TECHNICAL SERVICE BULLETIN

Subject:	Vacuum Motor Connections
Product(s):	Condor BR1100/BR1300
System:	Recovery
Number:	TSB-FC-2013-116
Date:	18 JULY 2013
ODM/ECO:	A-08772
Urgency:	Level 2

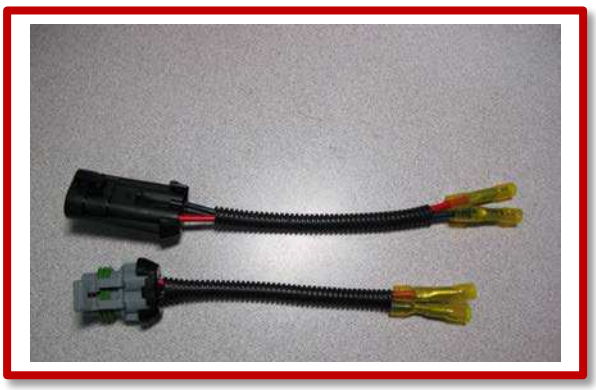
Poor connections at the vacuum motor to wiring harness interface

Poor fitment of the internal connections at the vacuum motor terminals

- Current production connectors upgraded to Delphi, Ducon 6.3 connectors which have heavier contacts and higher current rating.

1. Order part numbers **56383234** CONNECTOR ASSY DUCON MALE and **56383235** CONNECTOR ASSY DUCON FEMALE
2. Cut off old connectors and discard, then splice new connectors into existing wiring
